Duke Energy
Oconee Nuclear Station
7800 Rochester Highway
Seneca, SC 29672
(864) 885-3107 OFFICE
(864) 885-3564 FAX

SUBJECT: Duke Energy Corporation
Oconee Nuclear Station Units 1, 2, and 3
Docket Nos. 50-269, 50-270, 50-287
License Nos. NPF-38, NPF-47, and NPF-55
Licensed Amendment Request for Full-Scope
Implementation of the Alternative Source Term
and Technical Specifications 3.3.5, Engineered
Safeguards Protective System (ESPS) Analog
Instrumentation; 3.3.6, Engineered Safeguards
Protective System (ESPS) Manual Initiation;
3.3.7, Engineered Safeguards Protective System
(ESPS) Digital Automatic Actuation Logic
Channels; 3.7.10, Penetration Room Ventilation
System; 3.7.17 Spent Fuel Pool Ventilation
System; 3.9.3, Containment Penetrations;
5.5.2, Containment Leakage Rate Testing
Program; and 5.5.12, Ventilation Filter
Testing Program
Technical Specification Change Number 01-07

ATTACHMENT 1

**Marked copy of current Technical Specification pages
showing the proposed changes**

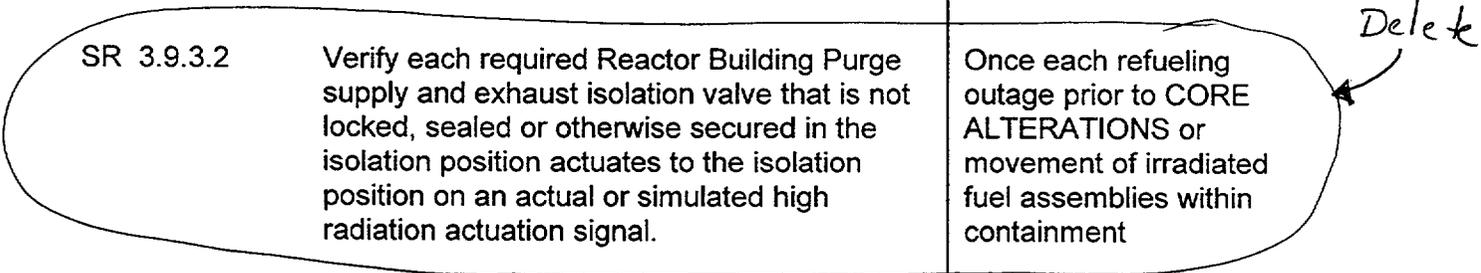
The containment penetrations shall be in the following status:

- a. The equipment hatch ^{is capable of being} closed and held in place by a minimum of four bolts;
- b. One door in each air lock ^{is capable of being} closed; and
~~NOTE
 An emergency air lock door is not required to be closed when a temporary cover plate is installed.~~
- c. Each penetration providing direct access from the containment atmosphere to the outside atmosphere, ~~either~~ ^{is capable of being closed.}
 - 1. ~~closed by a manual, non-automatic power operated or automatic isolation valve, blind flange, or equivalent, or~~
 - 2. ~~capable of being closed by an OPERABLE Reactor Building Purge supply and exhaust isolation signal.~~

The LCO for TS 3.9.3 is being revised to allow the containment air lock doors, the equipment hatch and each penetration providing direct access from the containment atmosphere to the outside atmosphere to remain open during fuel movement and refueling operations. The proposed TS would require that during fuel movement and refueling operations the equipment hatch, at
